McCULLOCH SERVICE BULLETIN #1001

SUBJECT Starter Base Assembly Procedure

MODEL 55 DATE 9-18-57

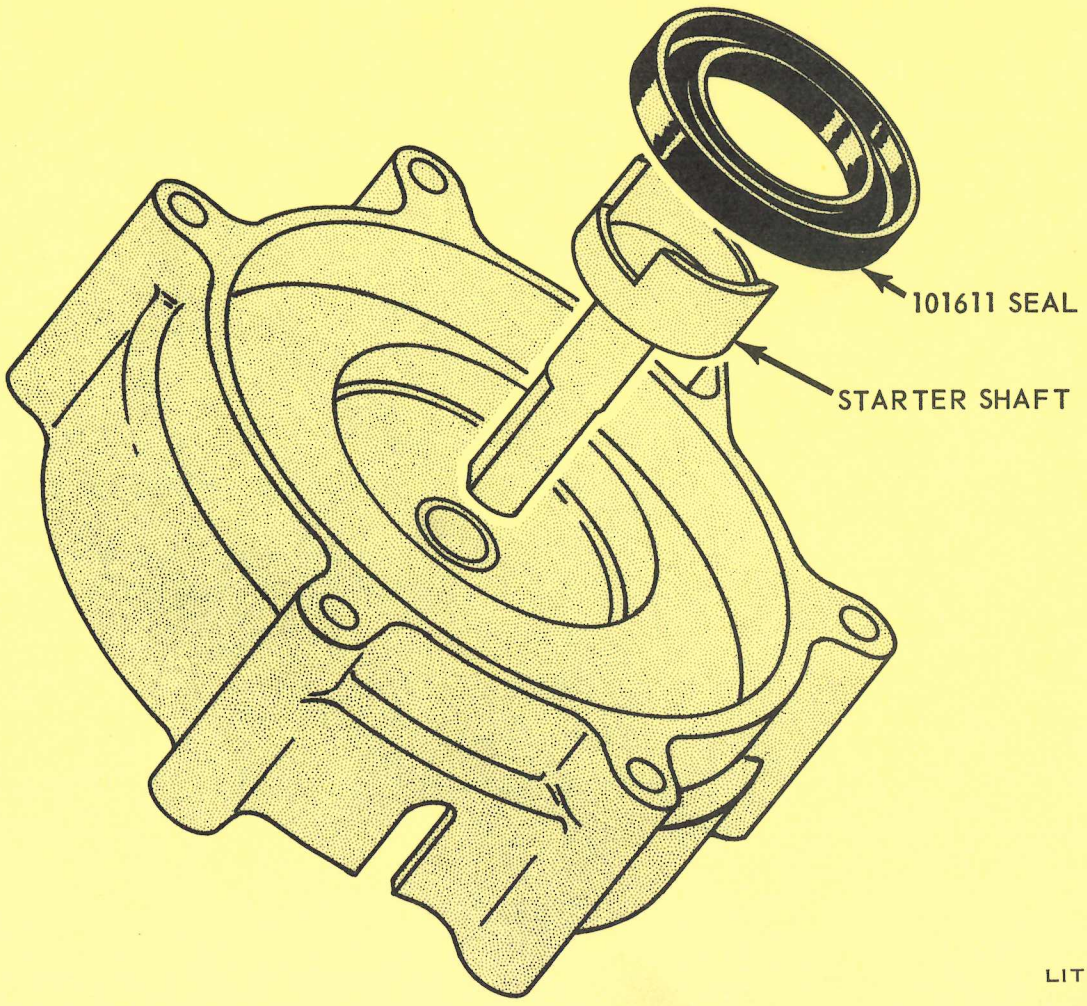
The Starter Base Assembly, part number 51648, which formerly included the base, part number 51649, the bearing, part number 103535, and the seal, part number 101611, no longer includes the seal. The seal has been eliminated from the assembly to prevent its lip from being damaged or distorted as the starter shaft is being installed.

When performing a service replacement with an earlier starter base assembly into which the seal has already been installed, the seal must be removed before assembling the starter shaft in the base. The seal should then be examined for damage and, if perfect, it may be slipped over the slightly oiled starter shaft and pressed back into place. If the seal has been damaged beyond reuse, or if the new starter base assembly, which does not include a seal, is used, a new seal may be ordered under its part number 101611.
